New Residential Development
At
16 Avenue Road
London NW8

Discharge of Planning Condition for SUDS

Application Ref: 2016/5375/P

Revision	Status	By	Approved	Date
00	draft	ad		25 01 2020
01	Issued for discharge of Planning	ad	mor	06 02 2020
02	Updated for Officer Comments	GW	mor	22 04 2020

**GROUND FLOOR PLAN
 DRAINAGE**

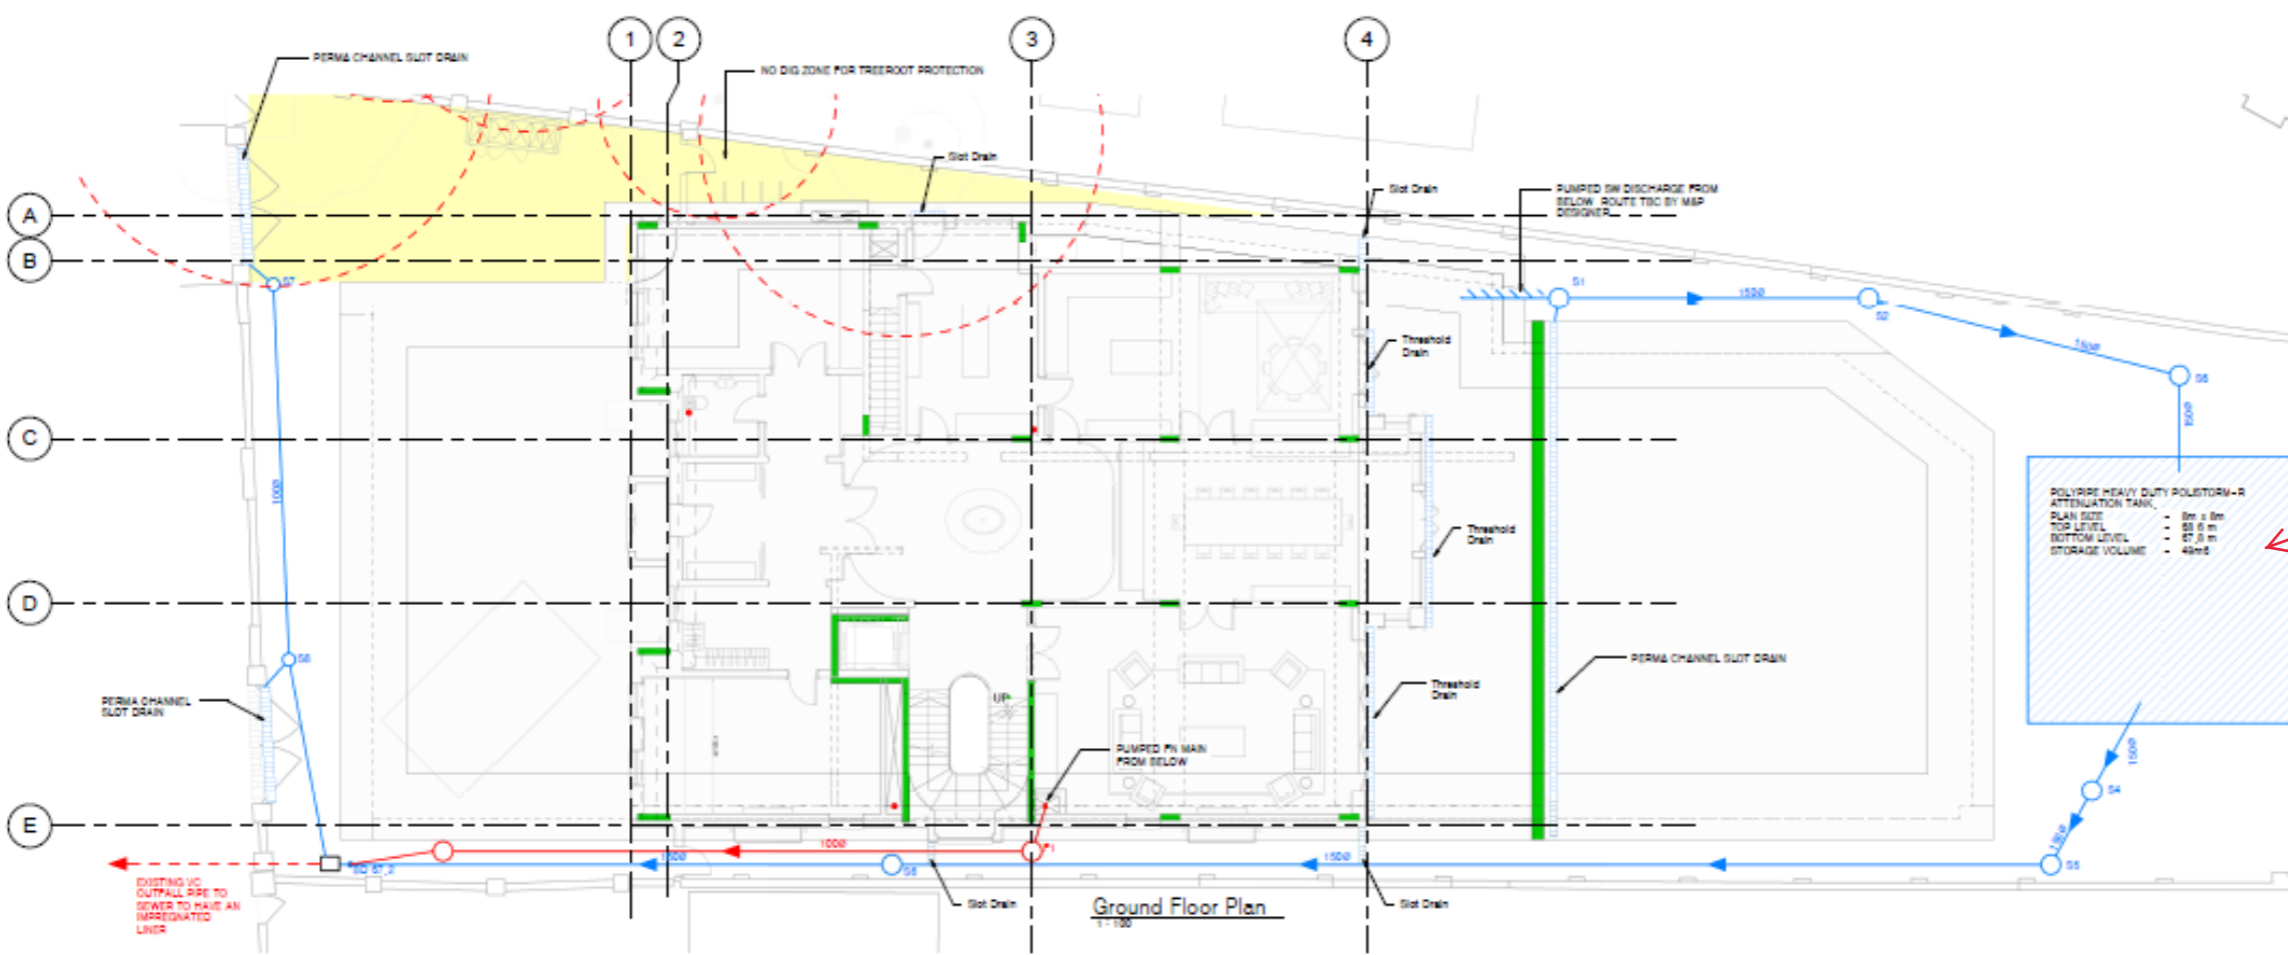
Approved Strategy – Drainage Statement rev. P3 (Elliott Wood, Nov 16)	Proposed pre-implementation – ‘Discharge of Planning Condition for SUDS’ rev. 01 (Ross & Partners, Feb 2020)	LLFA queries / issues	R&P Feedback Proposal
Submissions	Drainage statement Drainage drawings Drainage pro-forma CCTV survey Thames Water enquiry MicroDrainage calculations	Drainage statement Drawings	Missing updated docs including <ul style="list-style-type: none"> - SuDS pro-forma - MicroDrainage calculations - Thames Water acceptance letter 	-Revised pro-forma attached, -Detailed Microdrainage calculations attached and drawings included. Consultation with TWU is underway, however due to the current lockdown situations TWU have altered their feedback timings and therefore this element is pending.
Proposed impermeable area	785 m2	800 m2	Slight (2%) increase	944sq.m representing a complete electronic remeasure. Note existing impermeable area also is larger than previous estimations.

Proposed discharge rate (% change vs existing)	1:1yr 4.86 l/s (+0.2%) 1:30yr 4.86 l/s (-59%) 1:100yr 4.86 l/s (-69%) 1:100yr+CC 4.86 l/s	1:1yr 1:30yr 1:100yr 1:100yr+CC 7.44 l/s	Site discharge rate increased Rates missing for less severe scenarios	Defined within the pro-forma
Volume of storage required	32 m3	47 m3		52 cu.m
Proposed SuDS	Green roof Rainwater reuse (catchpits on surface water manholes, to grounds irrigation system) Permeable paving (front of site, drained to onsite network) Tank attenuation via below-ground geocellular crates (32 m3, rear garden) Vortex flow control (discharge restricted to 2.5 l/s)	Proprietary attenuation storage crates (47 m3, rear garden) Orifice controlled hydrobrake (1.06 l/s)	No information on area, soil depth & storage capacity of green roofs Permeable paving deleted & replaced with impermeable hardstanding with slotted drainage channels Hydrobrake discharge rate is expected to be lower than practically maintainable	Defined within the pro-forma Brown roof with delineated storage capacity. The front entrance Area was always positively drained with slotted drainage channels. Attenuation tank in rear garden. Hydrobrake system available to suitably reduce the flow rate. Refer to hierarchy schedules and SuDs Measures schedules. Modern Hydrobrakes can now manage flows as little as 1.0 l/s

POLYPIPE HEAVY DUTY POLYSTYRENE ATTENUATION TANK
 PLAN SIZE - 8m x 8m
 TOP LEVEL - 88.6 m
 BOTTOM LEVEL - 87.8 m
 STORAGE VOLUME - 48m³

52cum Storage
